# ENCORE APARTMENTS

DPD # 3020094  
2ND DESIGN RECOMMENDATION  
20 DECEMBER 2016

**PROJECT ADDRESS:**  
3010 1st Ave.

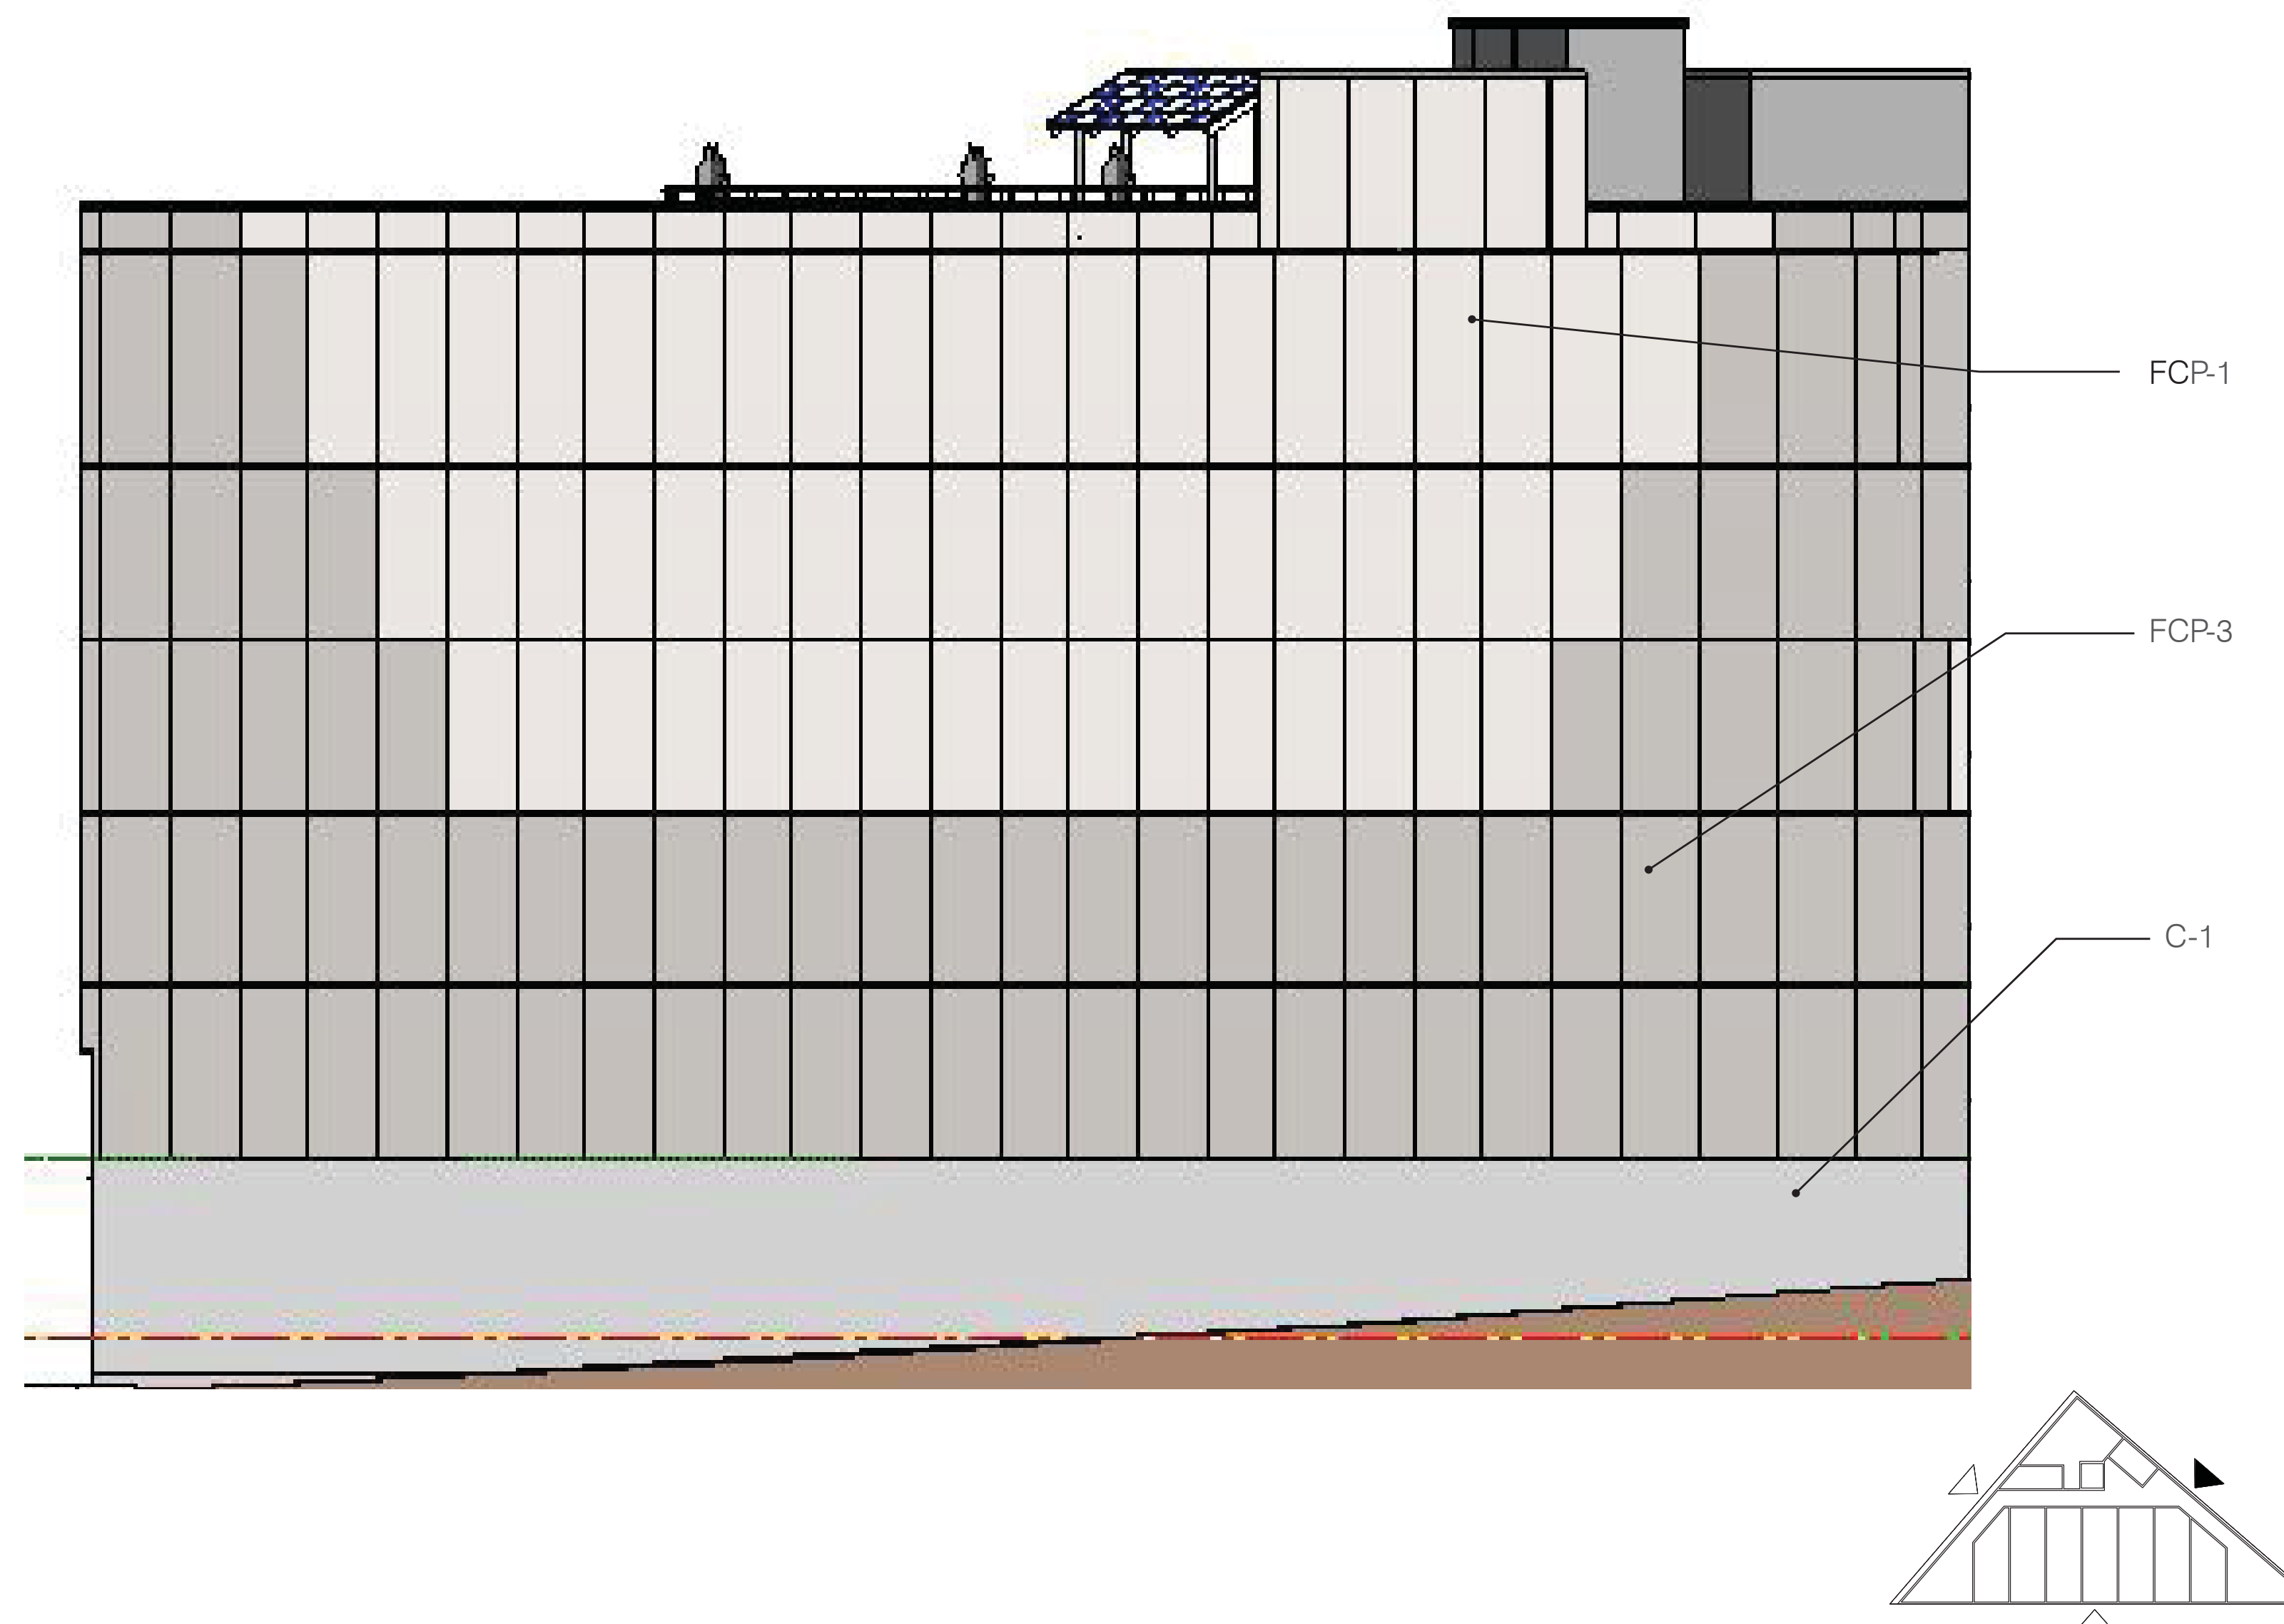
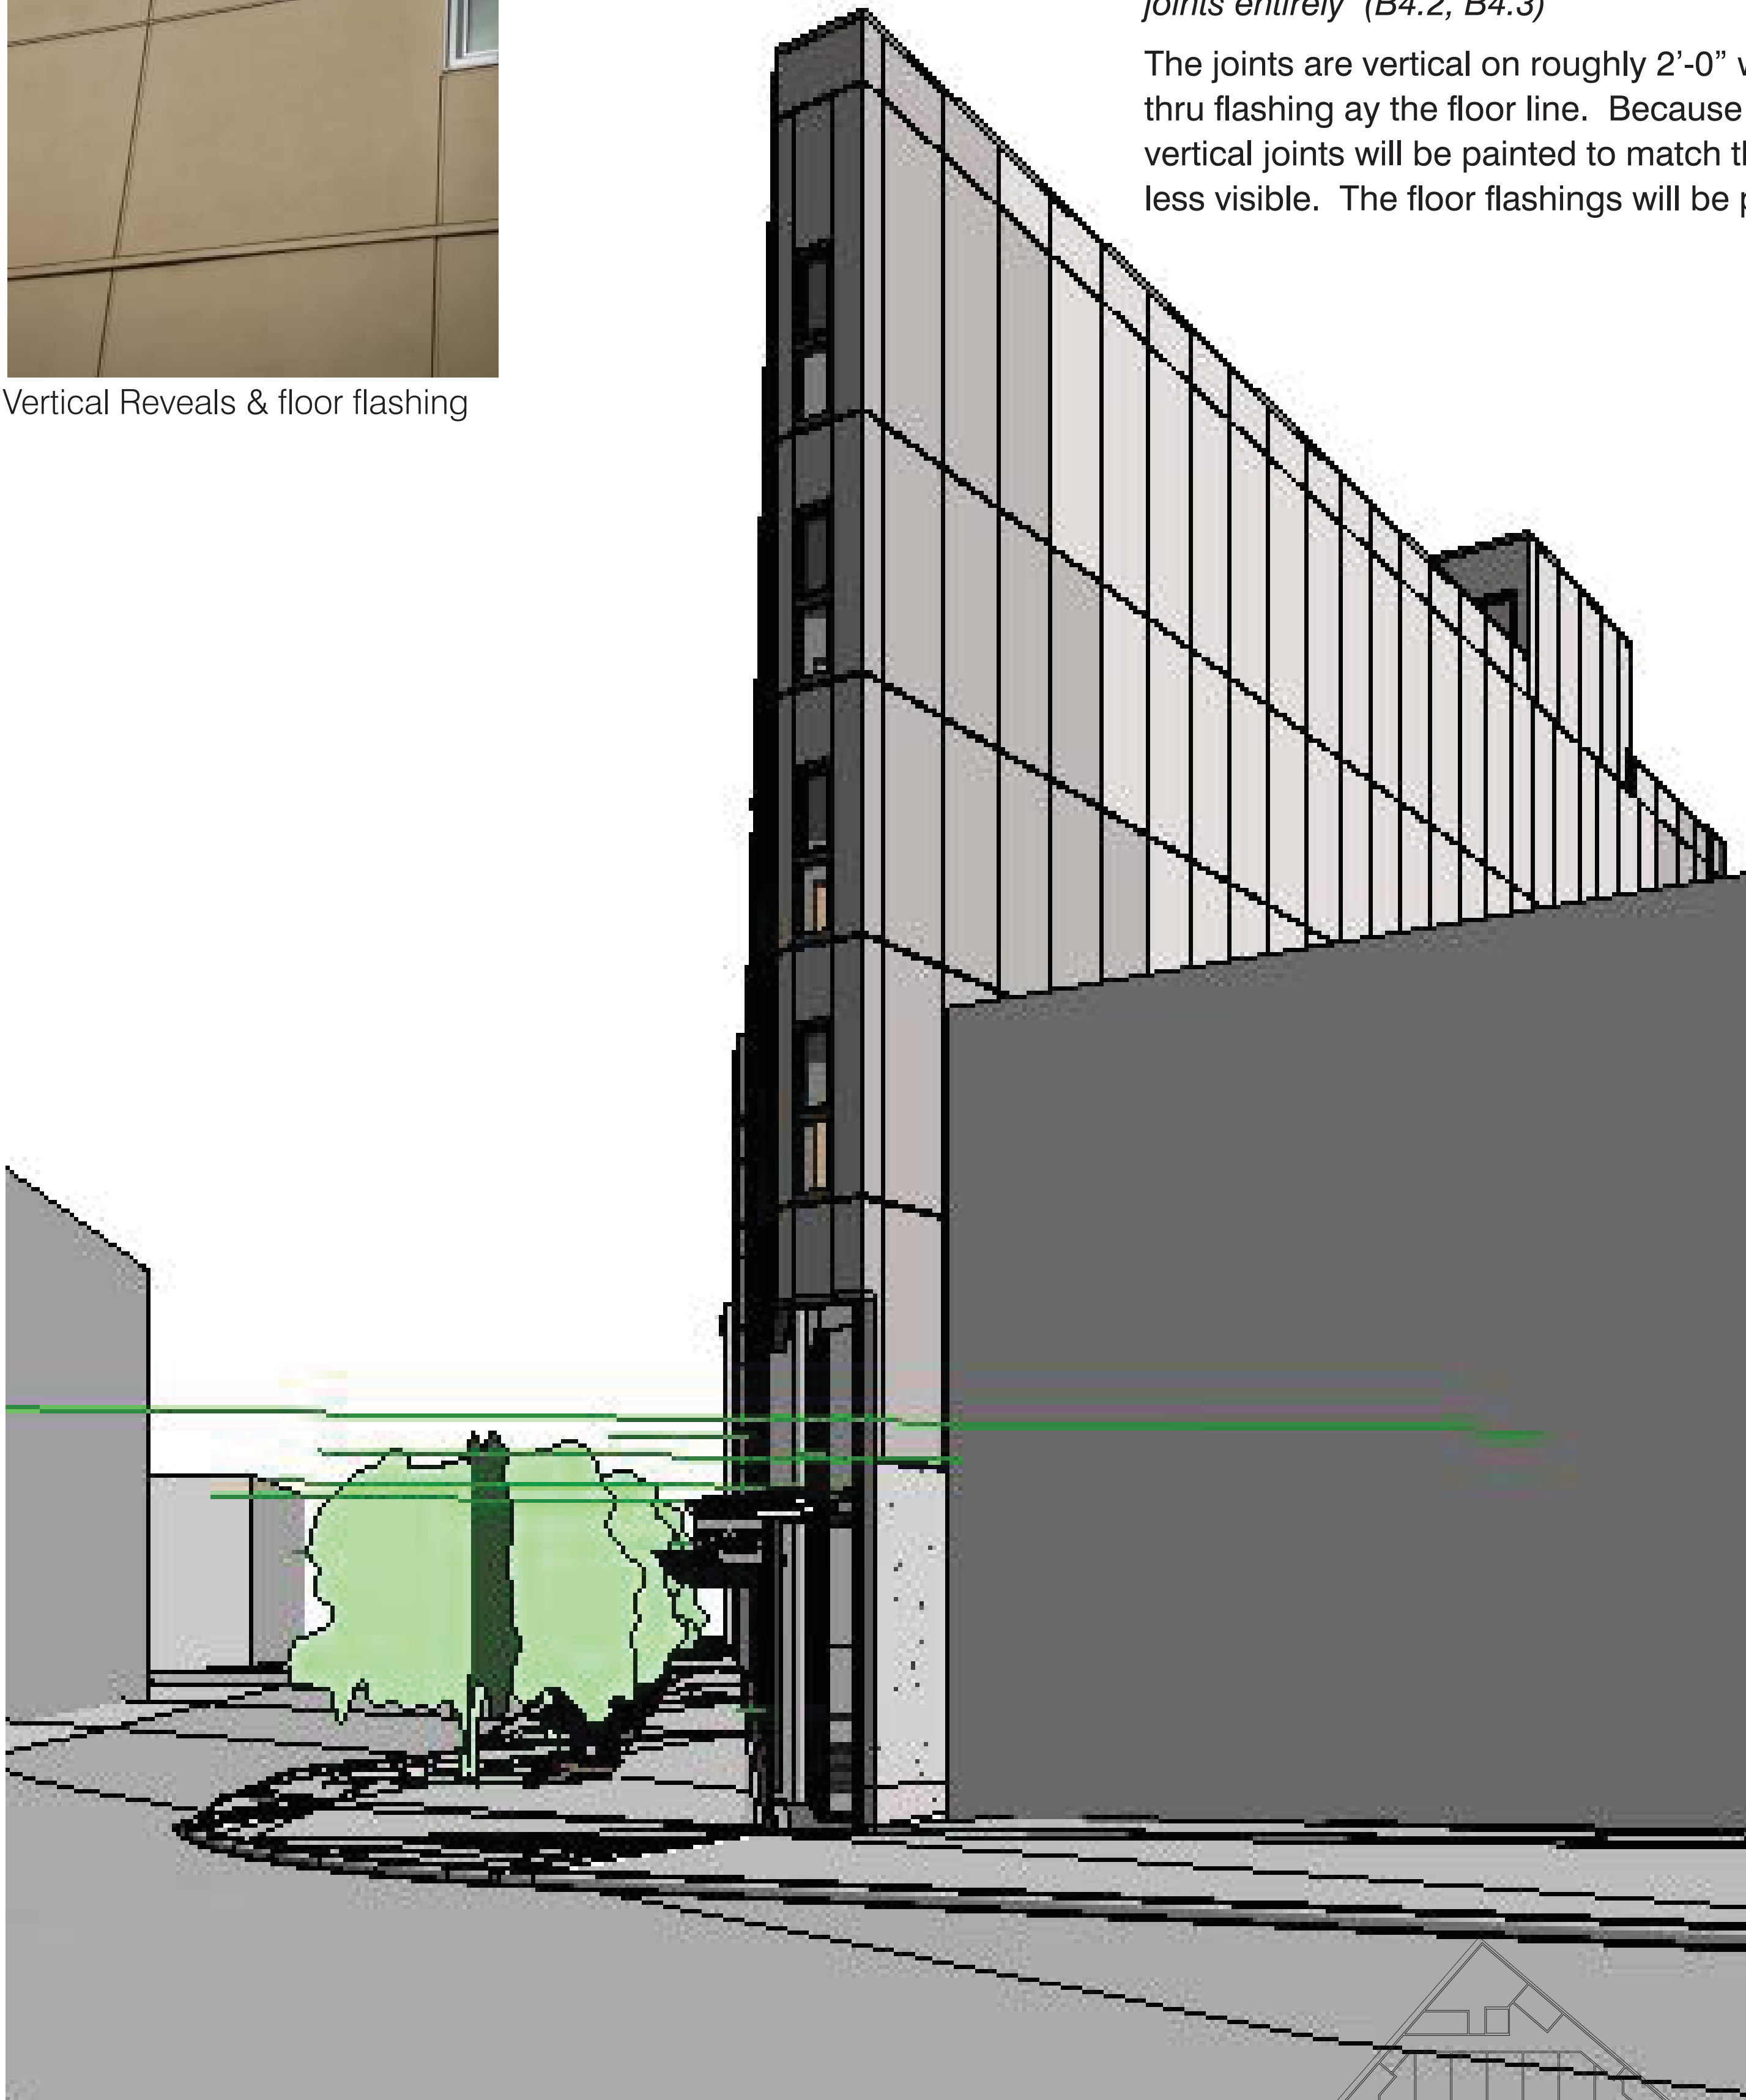
“...The Board agreed that the banding of color appears to take away from the wholeness of taut skin expression. The board recognized that the unique shape of the site warrants a quirky response...The Board strongly recommended more investigation of color, including considering a true pixelated gradation as opposed to the striated gradient shown (B4.2, B4.3)”

“...The Board agreed the loading area will be highly visible and recommended reconsidering the color and materials of the loading area including the walls and soffit. (B4, C1, C6, E3.1)”

Achieving a pixelated gradient with fiber cement panels involves, by necessity, a lot of horizontal and vertical joints. Because of the shift in adjacent colors, the joints would be painted one color; i.e, black. The more joints, and the smaller the fiber cement panels, the more difficult it will be to align them. This scheme has less variation in grays. Dark gray dissipates to light gray from bottom to top. Painting and maintenance will be less difficult than Alternate 2.

The walls and ceiling at the recessed area of the loading dock will be painted yellow.
